## R.W. Gillespie & Associates, Inc.

22 January 2021 (Revised)

Subject: Geotechnical Engineering Review of Gilman Street Temporary Support of  
Excavation Design  
Maine Medical Center Hospital Expansion  
Portland, Maine  
RWG&A Project No. 0557-031

## SECTION AT GILMAN ST LOOKING SOUTH TIEBACK 9 & 10

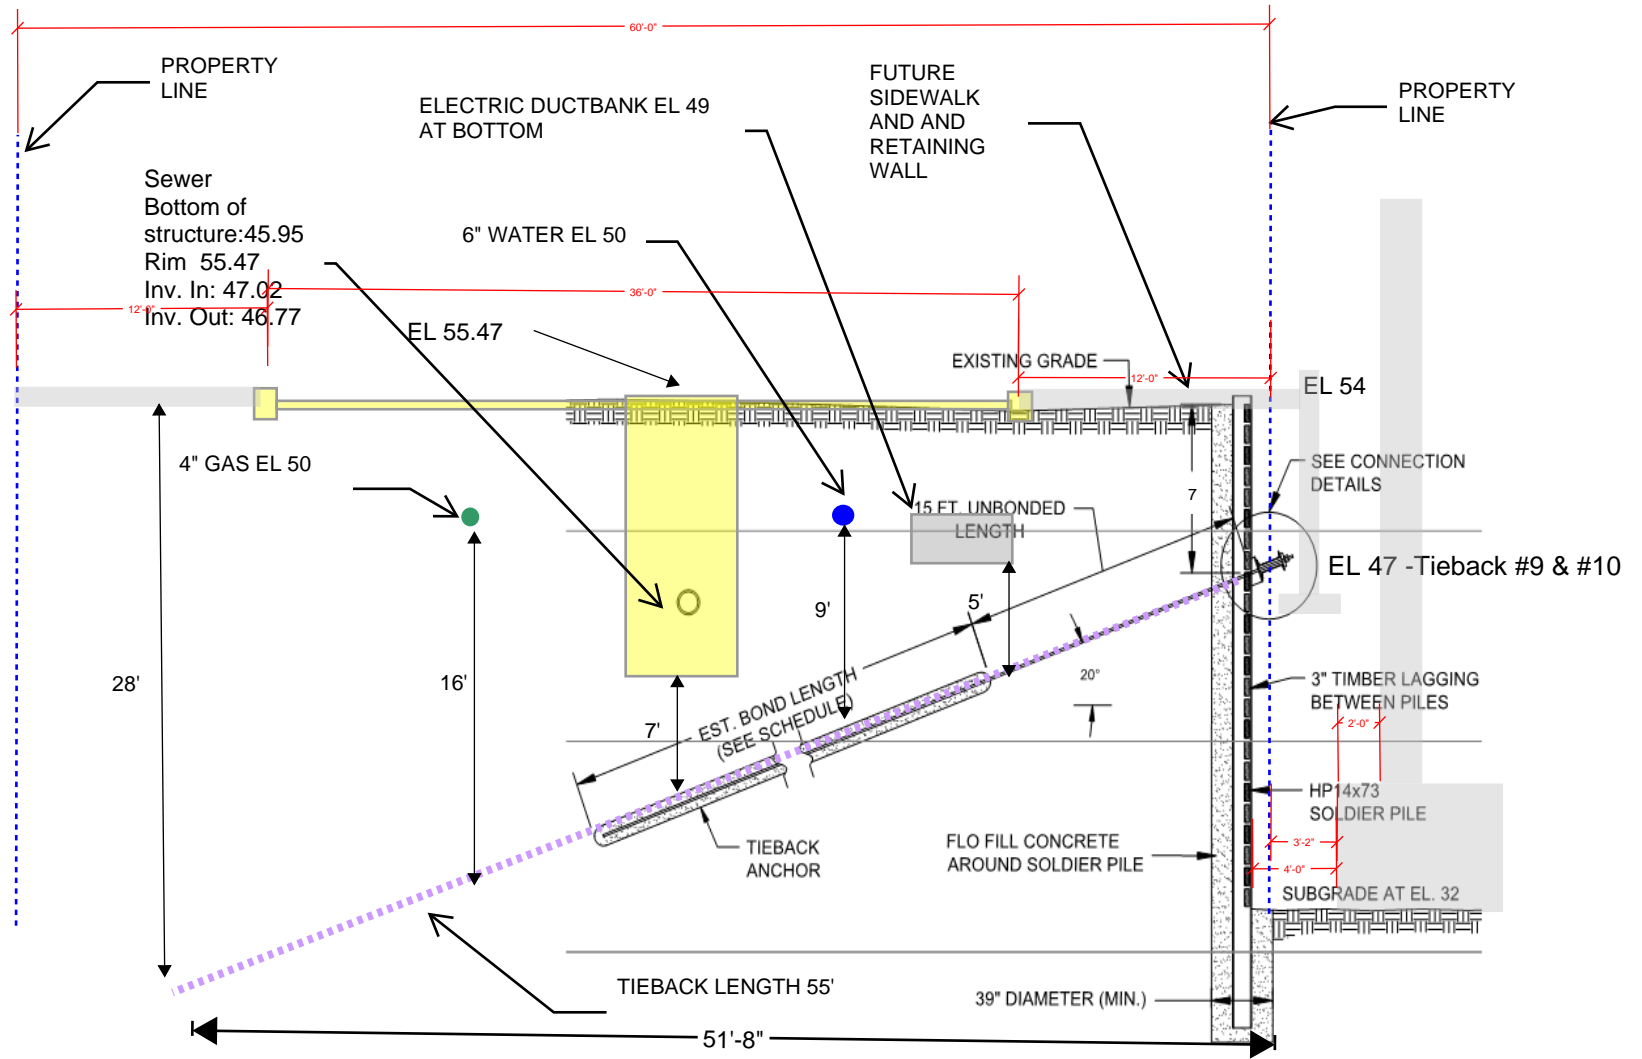
Based on the enclosed sketch titled *Section at Gilman St. Looking South Look South, Tieback 9 & 10*, the tiebacks would pass about 5 feet below an electrical duct bank, about 9 feet below a 6-inch waterline, about 5 to 7 feet below the bottom of SMH-8 and SMH-13533, and about 16 feet below a 4-inch natural gas pipeline at the west side of Gilman Street. The Contractor proposes to abandon four grouted soil tiebacks and four steel, H-shaped soldier piles in-place after the excavation between the SOE system and building foundation walls is backfilled. The H-piles are about 24 inches square in plan dimensions and would be surrounded by "flo fill" which we understand is a low-strength concrete. The sketch indicates that the "flo fill" and soldier piles would be removed to a depth 6 feet below the final grade after completion of foundation work.

Anchor Tieback Limits: The sketch prepared by Turner indicates that the Gilman Street right-of-way is 60 feet wide. The design calls tieback 65 feet long installed at a 20-degree downward angle. Based on the length and angle, the tiebacks would extend a horizontal distance of about 61 feet. It appears from the wale-to-pile connection detail that about 1 foot of the tieback would be located on the project side of the boundary, which would locate the end of the tieback very close to the Gilman Street westerly right-of-way boundary. If there are deviations from the design tieback lengths and inclinations, or in soldier pile positions, it is conceivable that the tieback might extend outside of the right-of-way and into the abutter's property.

*MMC should affirm that survey, construction, and design modifications are in place to assure that the tieback system will not extend beyond the westerly right-of-way boundary. The contractor should indicate how location, length, and angle control will be maintained and verified during installation.*
